: FLOAT STEP ASSEMBLY LH (206/407)

**Process Sheet**

: CU-DAR001 Dart Helicopters Services

: D2841 REV B

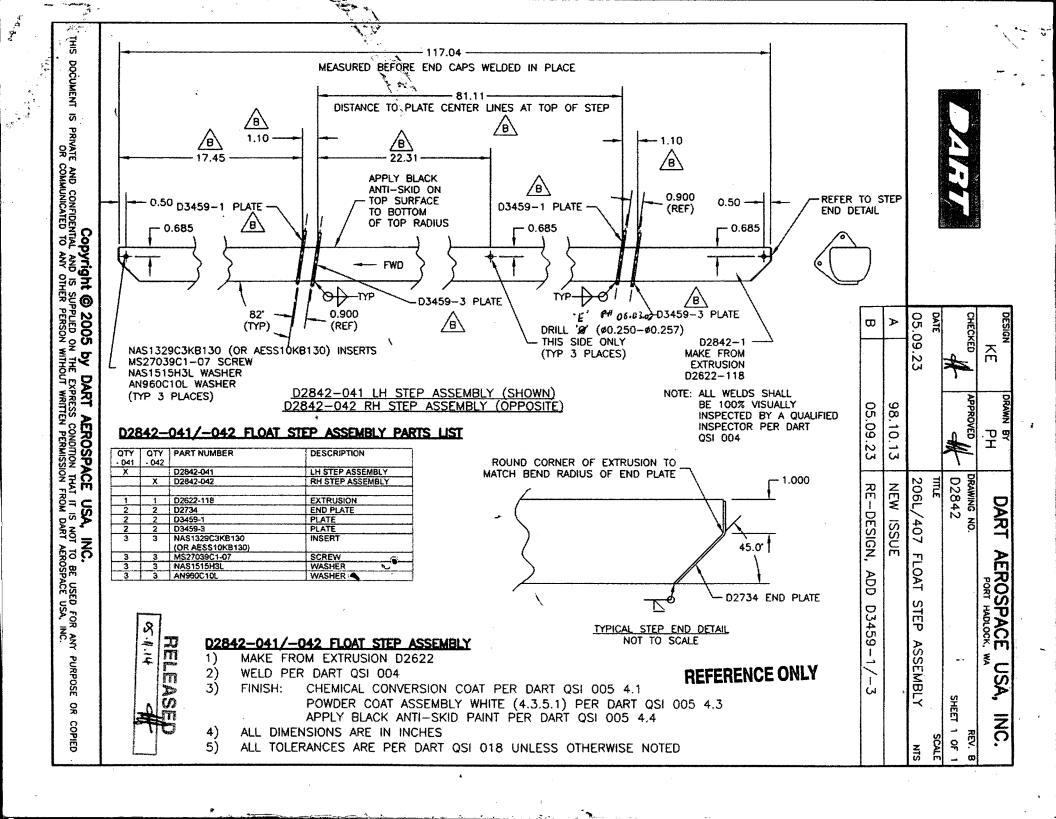
NCR:		W	ORK OR	DER NON-CONFORMANCE	(NCR)			
		Description of NC		Corrective Action Section B	· · · · · · · · · · · · · · · · · · ·	Verification	A	Approval QC Inspector
DATE	STEP	Section A	Initial Chief Eng	Action Description Chief Eng	Sign & Date	Section C	Approval Chief Eng	
gnzz	2	Goods of stops bent inwards clue to welding the logs to Dot, and the heatpulied the ends of the step in.	A 01.22	Steps are Acceptable. weld I lug at Atime, and let parts cool between welds.	K		Se. 77.22	
6 OL 22	2	Holechrilled on both sides of steps. Hole only to be onere side.	A	Fill holes with weld and grind flush as per as 1 oc4.	06.02.27			06.20
	4.,			See Attateled E-mp. 1.	04.02.27	(un.25	West.	106.022
				·		/		,

> it possible that the 206 jig isn't restricting the step
> from moving on you? Does the welder have to move around from front to
back?
>
 David
  ---- Original Message ----
 From: "Peter Hum" <phum@dartaero.com>
> To: "David Shepherd (E-mail)" <davids@dartaero.com>
> Cc: "Jason Murdoch (E-mail)" <jmurdoch@dartaero.com>
> Sent: Tuesday, February 14, 2006 6:06 AM
  Subject: new 206 step welding
> > Hi David,
> >
> > In welding the new 206 step lugs, there has been some bending of the
> > due the heat of the weld. Between the lugs the step is straight. Between
> > lugs and the ends (short distance), the step bends as shown in the
>
  picture.
 > What should we do?
>
  >
```

The steps that bent during welding are acceptable. With respect to the #30 holes that were drilled on the wrong side of the step, fill them with weld per QSI 004 and grind flush.
